**DRB Plan Review - Fail Fernanda Sotelo Ph: email: [FernandaSotelo@miamibeachfl.gov](mailto:FernandaSotelo@miamibeachfl.gov)**  
**Comments: JGM, FSC Comments#**

LEHRMAN COMMUNITY DAY SCHOOL  
727 Lehman Drive / 77th St. | Miami Beach, Florida 33141

FINAL DRB SUBMISSION

C1

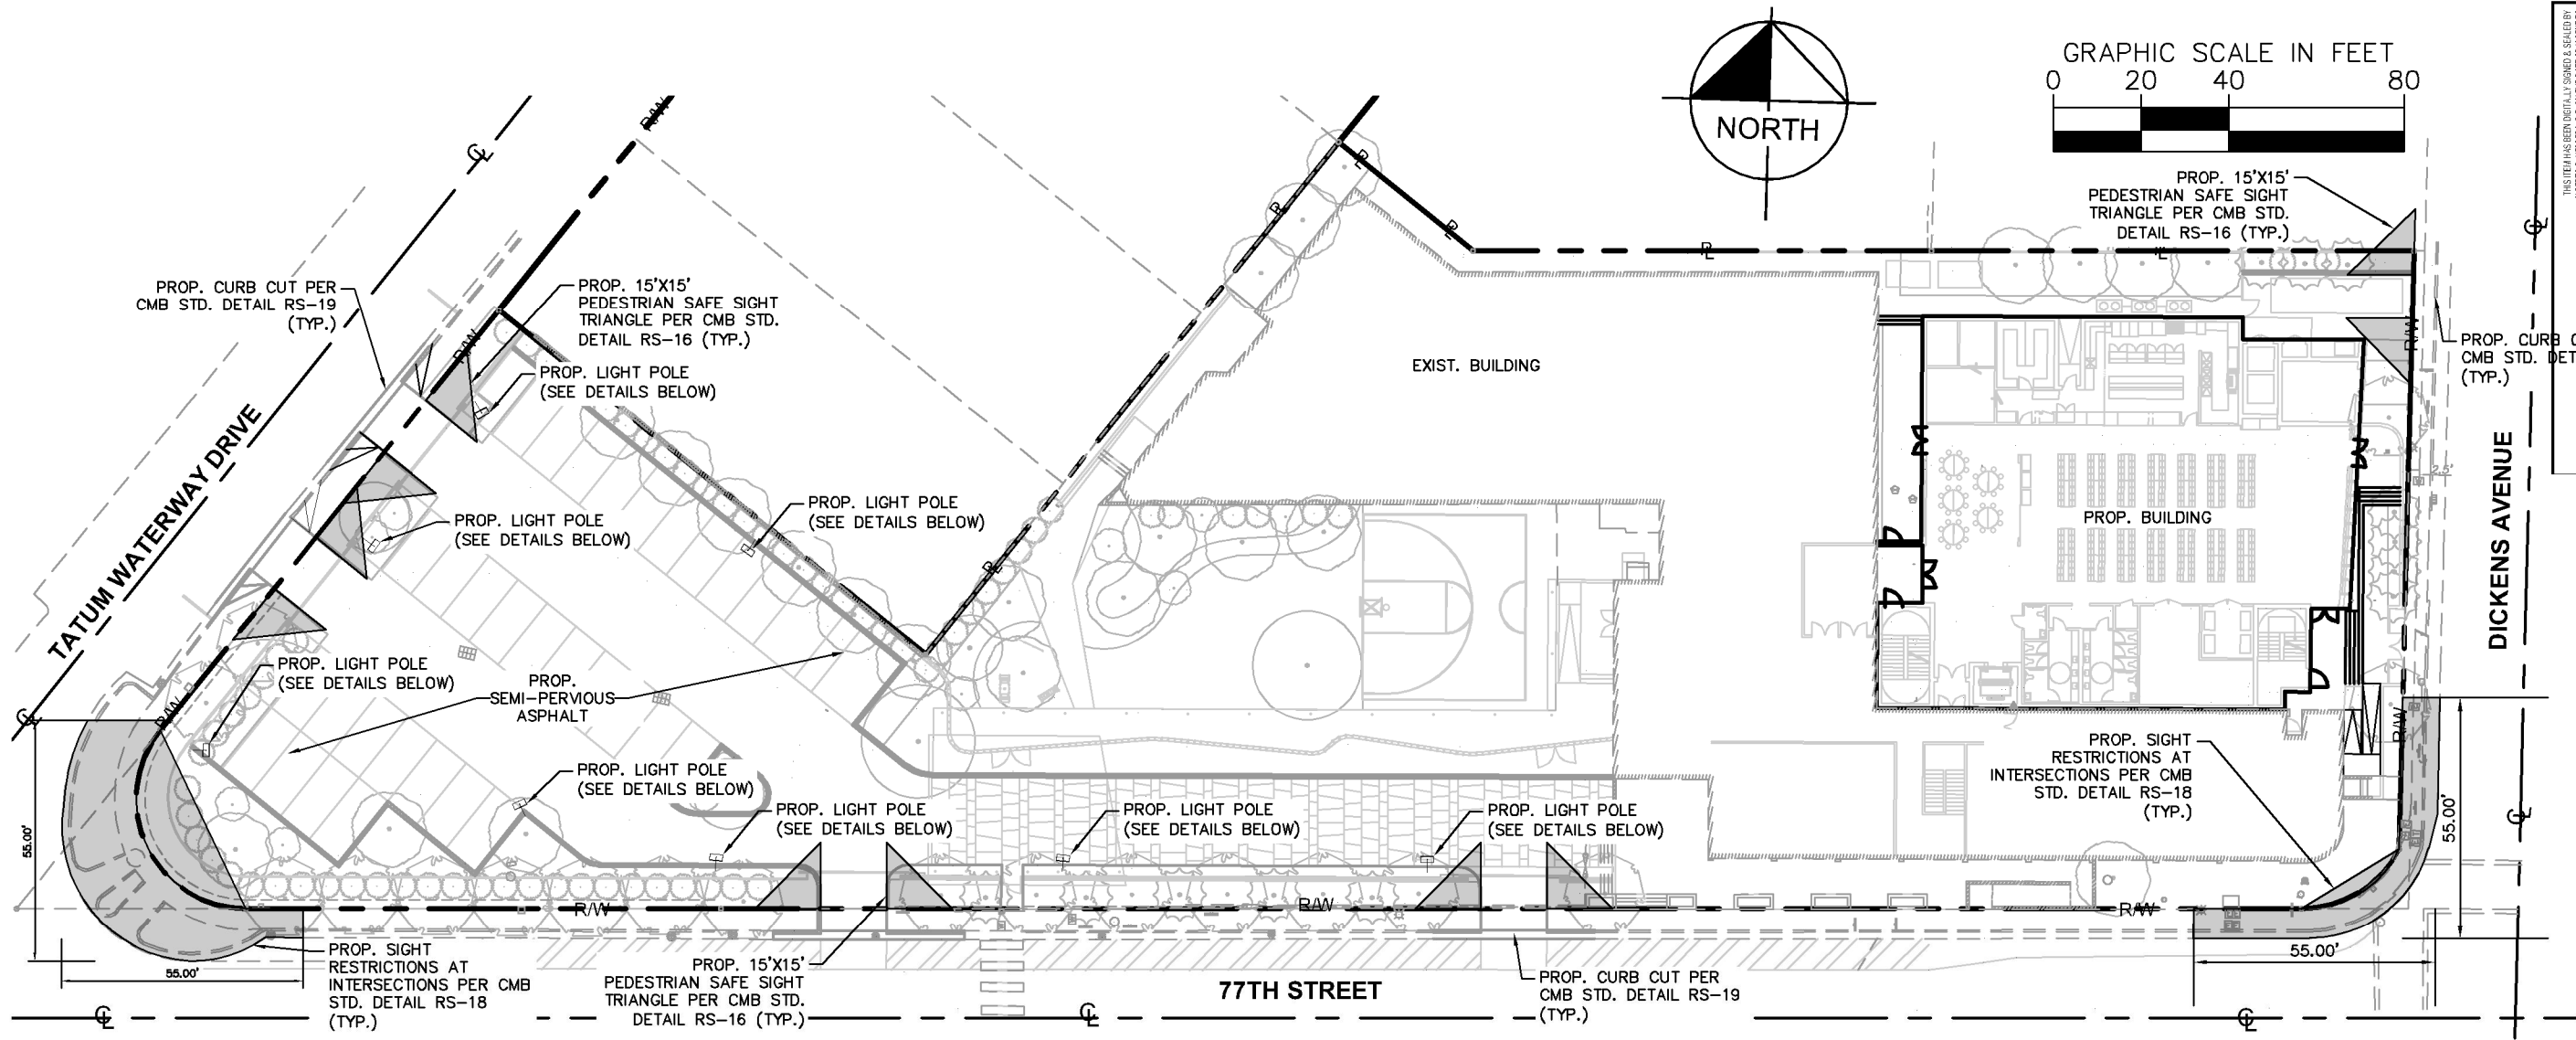
*a. Where is parking lot lightings? Height of poles?*

**Please refer to sheet number C1 for our light pole exhibit. This exhibit reflects the light pole locations and also the 13' mounting height of the poles. Additionally, landscape uplights are shown on sheet L4.**

TREE DISPOSITION & PROTECTION PLAN

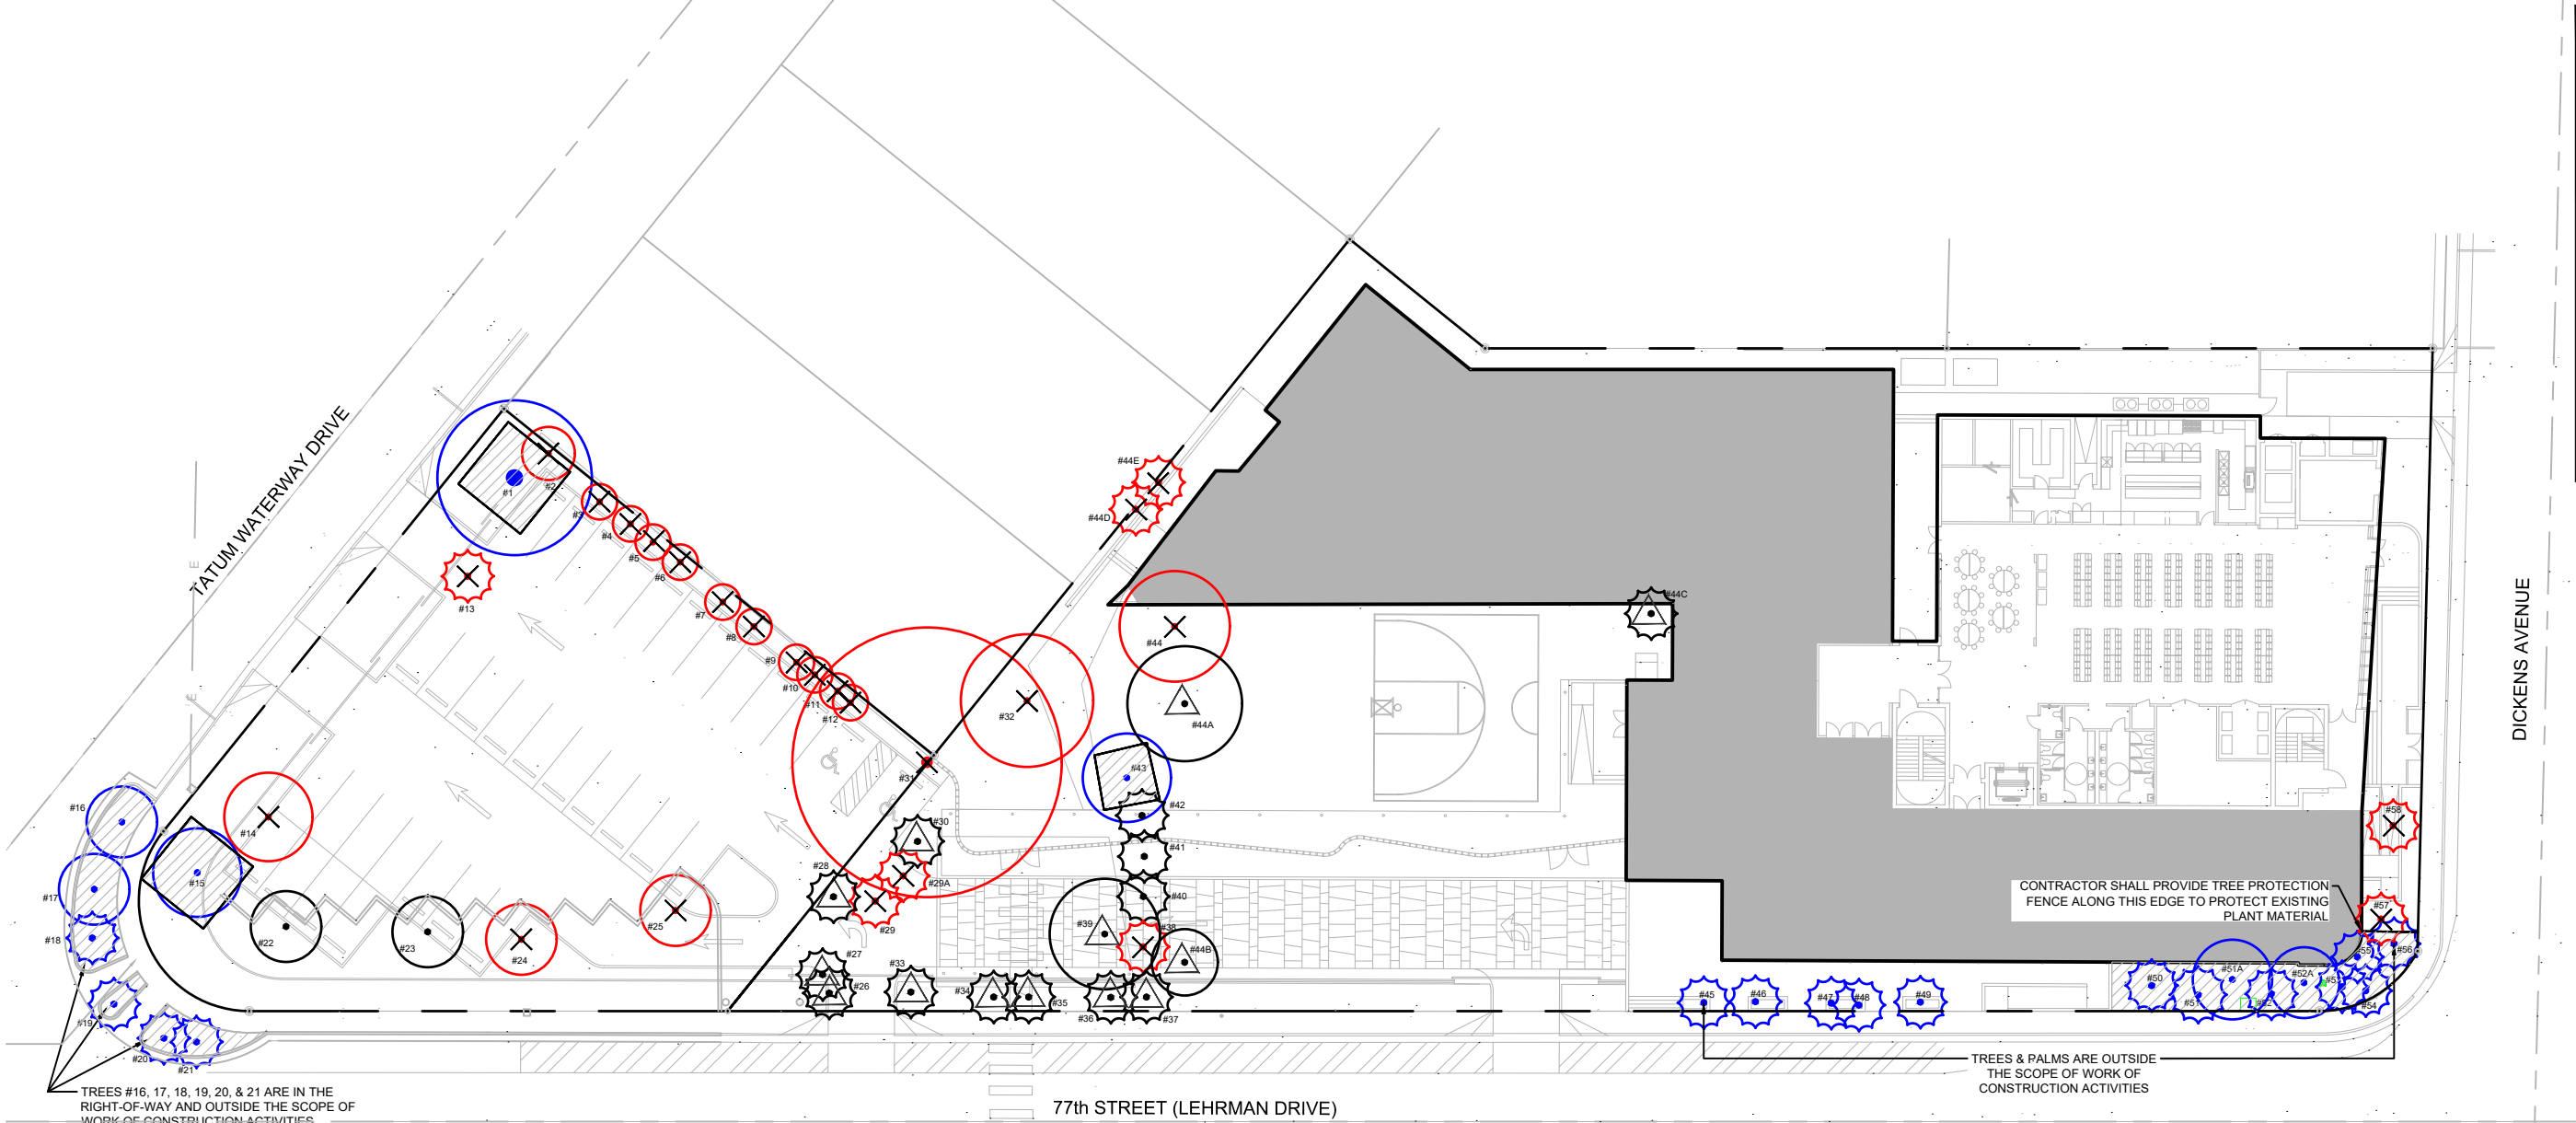
*1. Tree Protection fence for existing trees and palms to remain shall consist of a 4' chain link fence with metal posts as per CMB Code Chapter 46. Please graphically show the location of fence to the dripline on the Tree Disposition Plan.*

**Tree Protection fence detail consistent with CMB Code Chapter 46 for existing trees and palms has been added to sheet L2A Tree Protection Fence Detail. The location of the fence has been graphically shown to the dripline on the Tree Preservation / Disposition Plan, unless it is acceptable to be smaller per the arborist report. Some of the larger trees have 30'+ canopies but are listed with a 12'-18' TPZ/CRZ per the arborist report.**
